U. S. NUCLEAR REGULATORY COMMISSION

Report No. 50-206/90-27

Facility Name: San Onofre Nuclear Generating Station Unit 1

Inspection Summary:

Figure 1. Cross Sectional Plots of the Ultrasonic Beam Location and UT Indications with respect to the ID Surface Contour of San Onofre Unit 1 Steam Generator Welds.

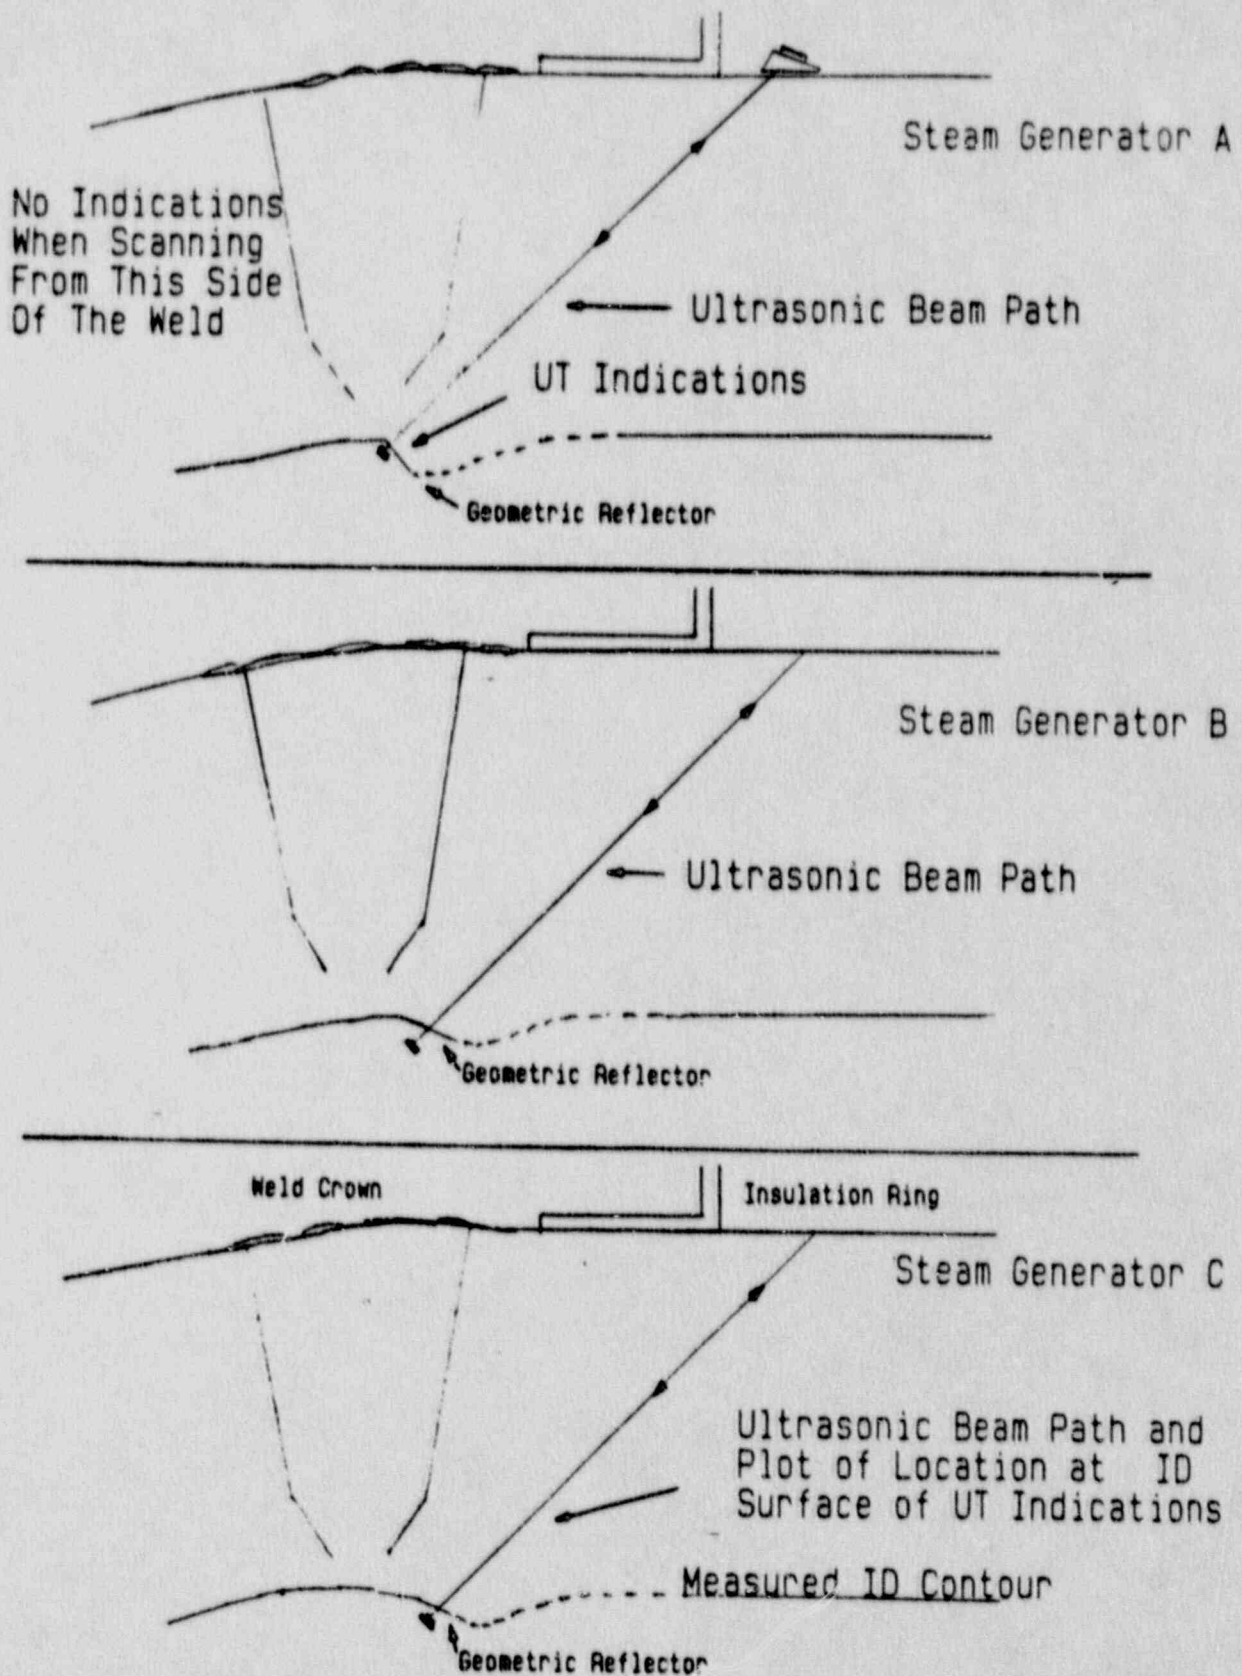
Several indications recorded above 50% DAC were located at the ID surface of the weld in all three steam generators. On all three generators the indications were recorded only from one side of the weld. From UT thickness measurements and contour profiling of the ID surface, the indications were determined to be generated by geometric reflectors at the ID surface and not from cracks at that surface. An actual ID profile measurement was made on the C generator at the location of an indication with a profile gauge. A plot of the cross section of the welds at the indications as generated by Robert W. Pechacek of Combustion Engineering in 4-1-1986, are shown in Figure 1. The plots of the UT indications shown for the three welds were made by Mr. Pechacek who did an independent evaluation of the indications for Southern California Edison in 1986.

The positions of the plotted UT indications is consistent with the presence of the geometric ID surface being almost perpendicular to the ultrasonic beam. The geometry of the ID surface is also consistent with the fact that no UT indications were recorded with the ultrasonic beam directed from the opposite direction to the weld.

Therefore, it is my conclusion that the UT indications are not from cracks since indications were not recorded from both sides of the weld, and the recorded indications are consistent with the geometry of the ID surface plotted in Figure 1.

Figure 1 Scan at the top of the tube sheet with a motorized rotating pancake probe.

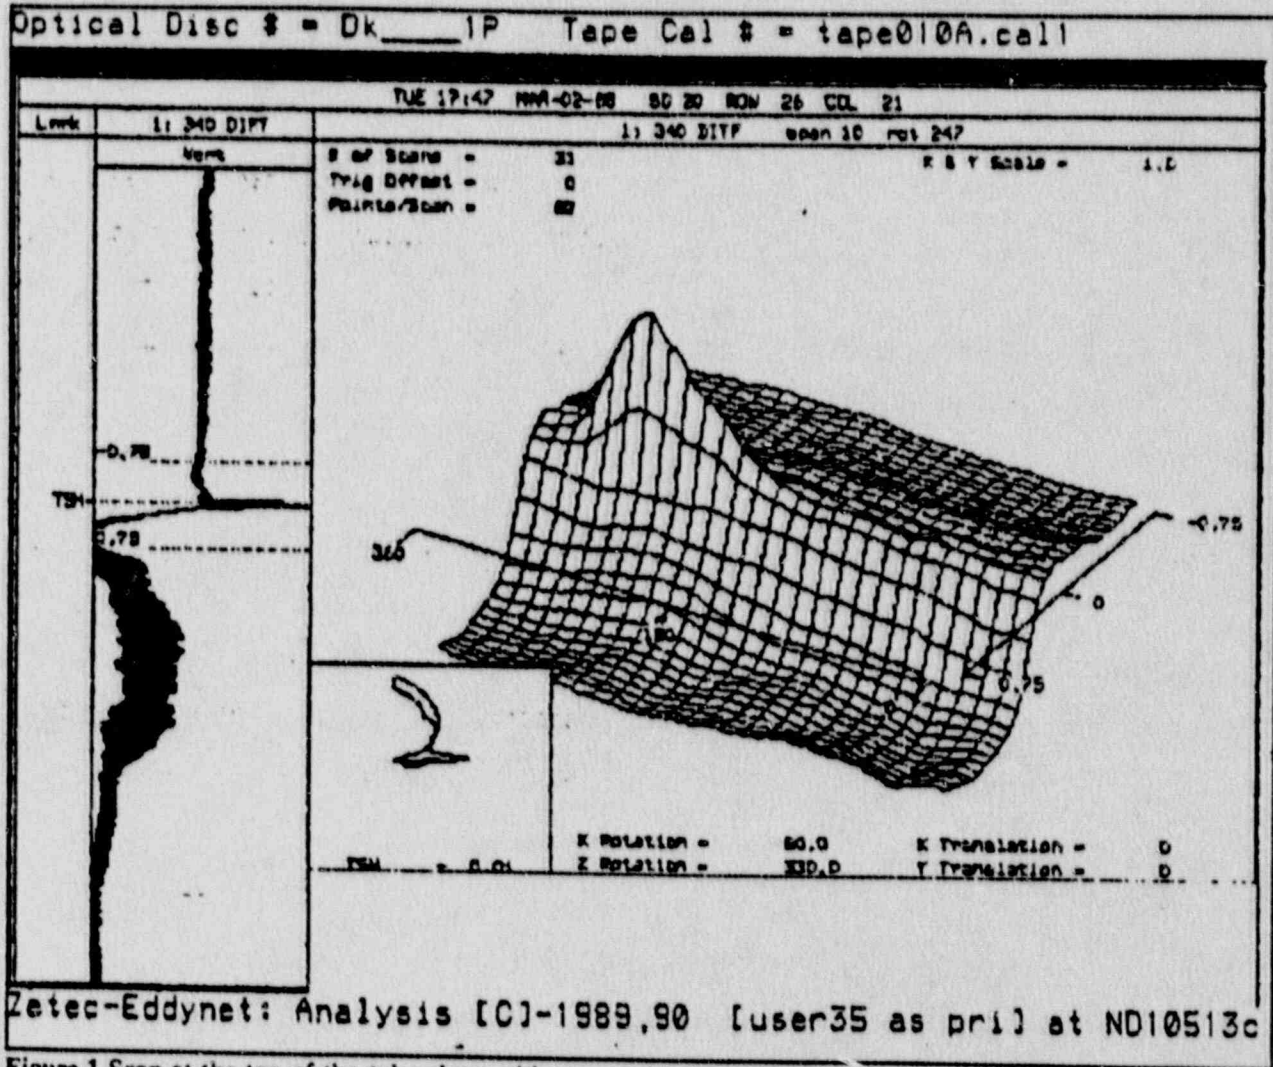
One crack-like defect was detected at the top of the tube sheet with the rotating pancake probe, as shown in Figure 1. This defect was missed with the bobbin probe. The defect was present on a review of the 8X1 inspection made in 1985, but not called at the time. This emphasizes the need to scan at least a sampling of the tubes at the top of the tube-sheet with the rotating pancake probe. About 600 tubes can be scanned in a day with the rotating pancake probe. The rotating pancake probe is about half the size of the pancake probe in the 8X1 array and therefore has a better response to small defects. The lift-off compensation technique used for the pancake probes by Zetec is outdated and interferes

with the measurement of the defect depth. Therefore, no calibration of the defect depth is made. I would recommend that the lift-off compensation method be updated and that the defect depth be measured. The depth of the defect in Figure 1 measures between 50 to 70 %.
